**Millstone Nuclear Power Station, Unit No. 3
License Amendment Related to the Supplementary Leakage Collection and
Release System (PLAR 3-98-5), Supplemental Information**

License Amendment Related to the Supplementary Leakage Collection
Release System (PLAR 3-98-5)
Response to Requests for Additional Information

Figure 1 - Plant Isometric

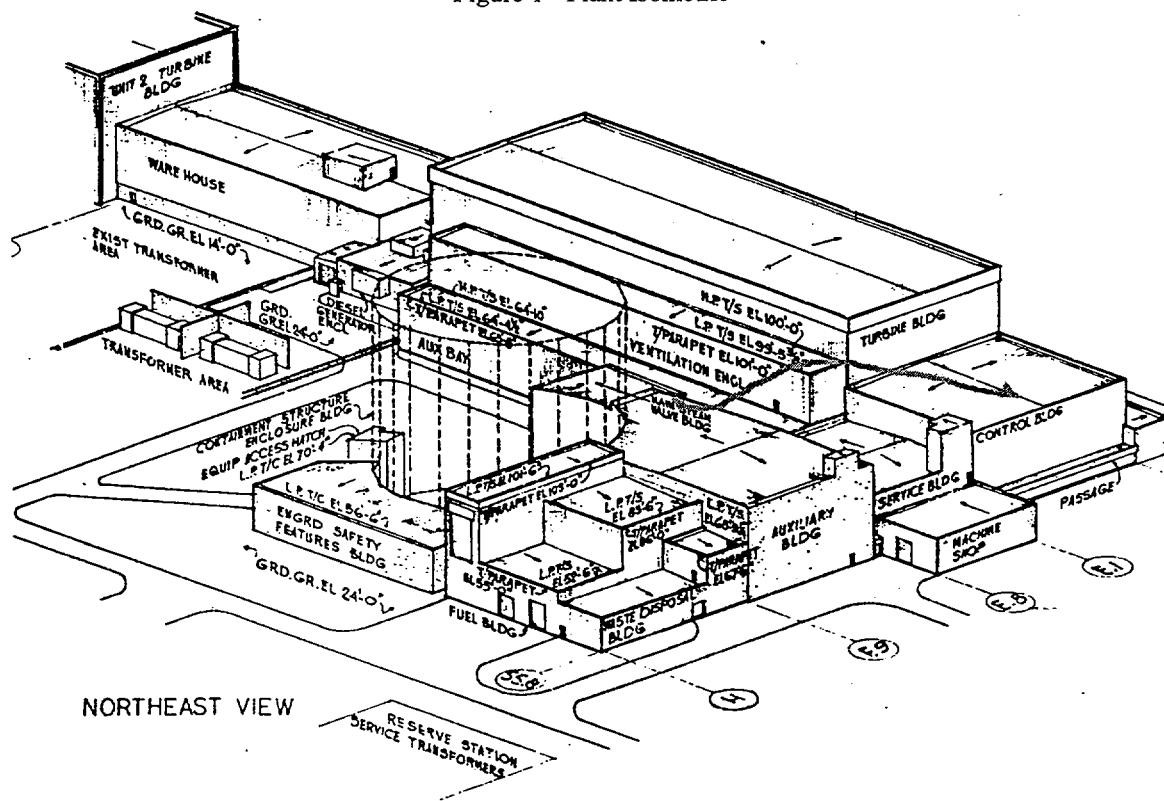
Stone and Webster calculation dated May 27, 1998, on X/Qs from the Unit 3 main steam building (MSVB) states that the postulated effluent release for the MSVB bypass scenario does not meet the Murphy-Campe criteria for using the diffuse source equation. However, a general statement is made that because of multiple flow disruptions due to buildings both upwind and downwind of the release, it is reasonable to assume that this equation may be used to estimate resultant X/Q values. The calculation assumes that the release occurs from the vent closest to the control room intake and mixes in the wake of the MSVB.

S&W calculation WM(B)-01, dated May 27, 1998, calculates the X/Q from the Unit No. 3 Main Steam Valve Building (MSVB) to the MP3 control room using the diffuse source equation of Murphy-Campe. The diffuse source equation was used to estimate the X/Q even though the elevation difference between the MSVB release point and the control room intake meet the criteria of the point source - point receptor technique of Murphy - Campe. The justification for using the diffuse source equation is based upon the aerodynamic obstacles encountered by the plume in the straight line pathway between the two points. Figures 1 and 2 depict the postulated flow path that the plume would have to travel from the MSVB to the Unit 3 control room intake.
